SPIRE-RAL-NOT-001637

## SPIRE L0 THERMAL STRAPS.

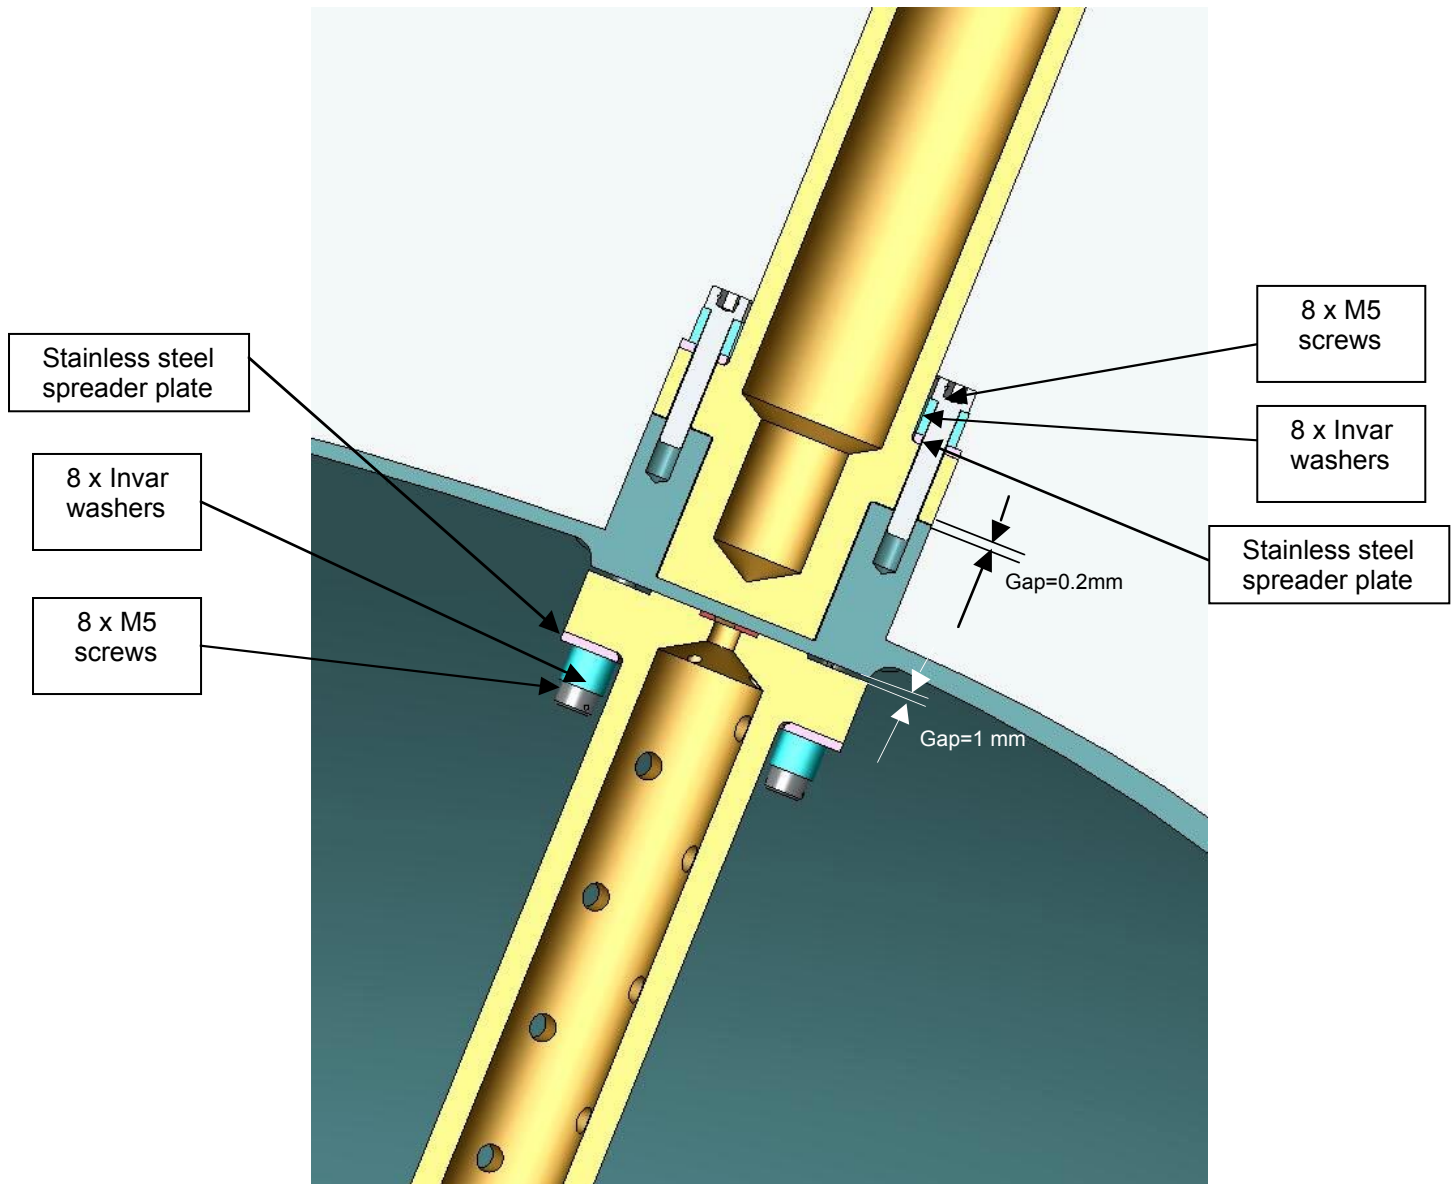
The thinned 5083 tank wall in the centre disc is computed on page 19 of RD-1 to have a conductance of 400mW/K. This uses a conductivity of 1.7W/m-K at 1.7K. for 5083. Were the value I use of 1.23W/m-K to be correct for this material as machined, its conductance would be only 289 mW/K. This miniscule element alone would then have less conductance that Spire proposed for the whole HeII to instrument I/F section.

There's a more major problem with this tank closure however. The geometry shown above, if not prejudged as to function, might otherwise be taken to be a punch aimed at removing this central disc! At the very least I would expect stress corrosion and He leaks at the rim around its periphery. The inclusion

of the two “special gaps” increases the tendency of this disc’s periphery to flex/shear with any rocking motion transmitted via the tensioned bolts’ elasticity.

I like the internal cone for ground use, the way it keeps a circulating HeII film close to the cone’s outer end, and the use of invar to maintain bolt tension. I would actually throw away the stainless steel spreader plate and make a drilled Invar annulus instead, one piece instead of 9, although heavier, as it would a better load spreader for He sealing (see later, but it only includes one set of bolts and one spreader).

I don’t like un-inspectable fasteners inside the HeII tank, or the number of clamped interfaces in the thermal path.

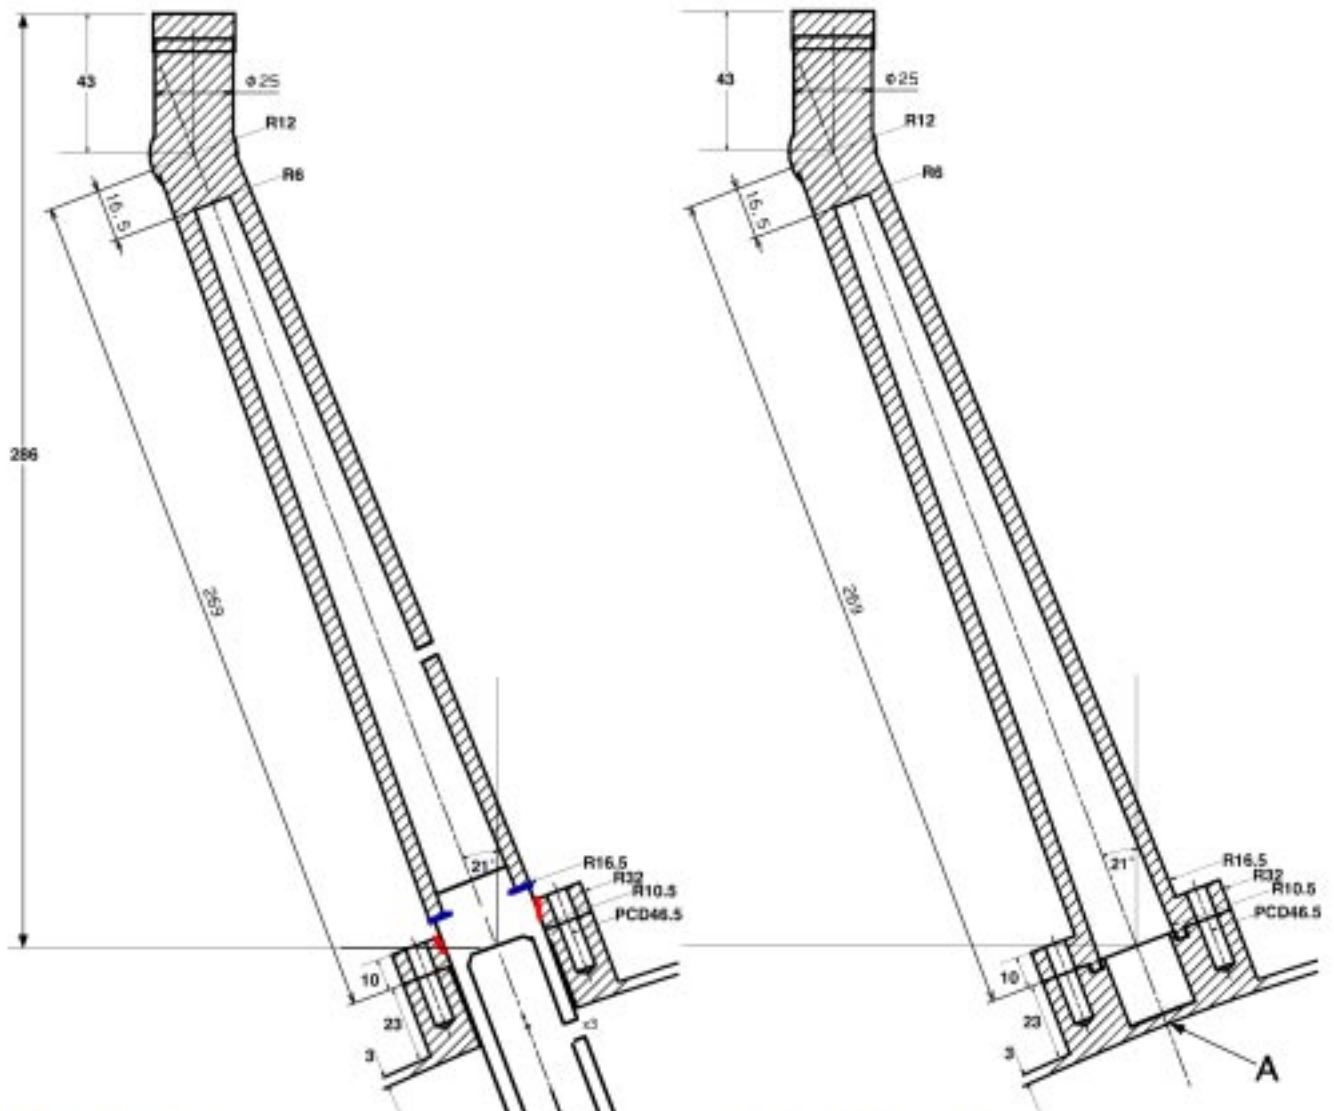
One out of order comment, if Air Liquide took the idea as per this last page and implemented it for all three Spire L0 straps, SPIRE-RAL-NOT-1594 suggests its conductance in flight would be 2170 mw/K in series with 600mW/K I/F conductance, combining to 470mW/K.. It also has:

- No He swilling about in cones
- Higher mass than the early Astrium solution but lower unbalanced moment
- No need for He to fill up into the outer cones on ground
- Welds configured on strap units ,which can be replaced from the outside the HeII vessel if needed, and which can be tested as subsystems (at 100Bar He?).

470mW/K is significantly above Spire’s most awkward 300mW/K request, we could all save our travel money and time, job done

Three parts to ease manufacture.  
Inside tube with 5083 flange ring welded on as in red.  
Outer empty thermal cone pushed on and welded as in blue.  
Inside tube and thermal cone both 5 nines Al, annealed before fabrication.

Reaches into cryogen on ground better and needs no fountain spray to be fitted.  
Has no thinwall parts in other than 5083 and no He going up extended external tubes.  
Has hard 5083 standard flanges.  
**HAS NO 5083 SECTION OR CLAMPED JOINT IN THE CONDUCTION PATH TO COOLER.**  
Gives mechanical balance about flange for moment of outer thermal cone...less launch leakage.  
Provided tank flange has been machined to suite metal

seal, can be implemented as a rework of a closed tank as per r.h.s. picture.  
No fasteners (uninspectable) inside tank.  
No need, as in some schemes, to obtain high finish inside and outside at "A", to then maintain high pressures on it and avoid stress build-up around its edge (cycling+section change).

5083 flange probably needs final machining to ensure welding has not distorted it.  
Use of vacuum deep E-beam welding to minimise contamination of 5 nines Al.  
"Not invented here!"
